Panel Report

Whitehorse Planning Scheme Amendment C194

Planning Permit Application WH/2016/1196

6 December 2017

Figure 6: ‘Figure 7’ from Mr Liu’s evidence statement

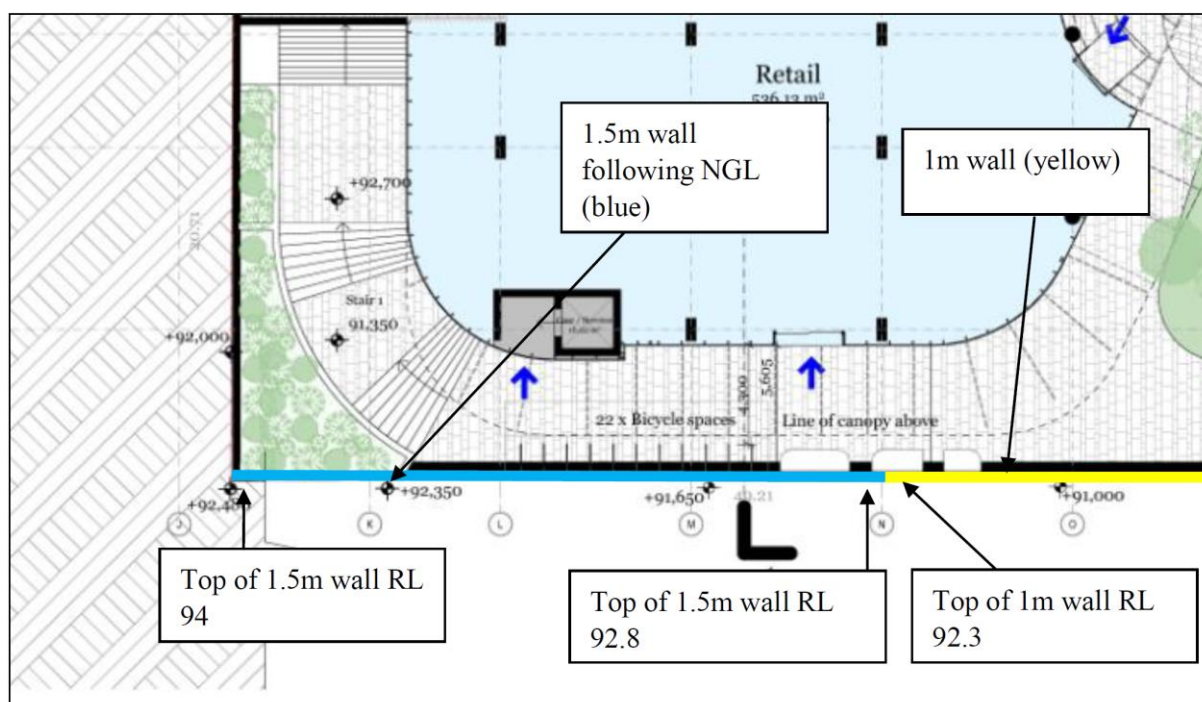
Mr Liu also gave evidence that loud voices or noisy trolley movements will ‘carry’ across to the church and these noises may be heard from time to time inside the Sanctuary. He noted that the area immediately north of the church is also proposed to be used for bicycle parking and possible outdoor dining. He recommended:

... a 1.5 metres high wall along the south boundary (church side) following the NGL to the extent shown in Figure 7 below to provide greater protection against such noises. A 1.5 metre high wall will be approximately RL 94 at the west end and approximately RL 92.8 at the east extent. A 1 metre high wall to the east will be acceptable as shown in Figure 7 (approx. RL 92.3 at west end and RL 91.5 at the east end). The wall should be of a solid construction, with mass 10-12 kg/sqm, with no gaps or cracks. Suitable materials include 6 millimetre glass, 15 millimetre perspex, 20 millimetre timber or 6 millimetre cement sheet.¹⁷

- (a) the construction of a 1.5m and 1m high fence along the southern boundary with the Church buildings (the Sanctuary building and Oxford Hall) in accordance with Figure 7 of the evidence report of Mr Darren Liu of Acoustic Control, dated 20 September 2017. The fence must be of solid construction with a mass of 10 – 12kg/sqm with no gaps or cracks. Suitable materials could be 6mm glass, 15mm perspex, or 20mm timber.
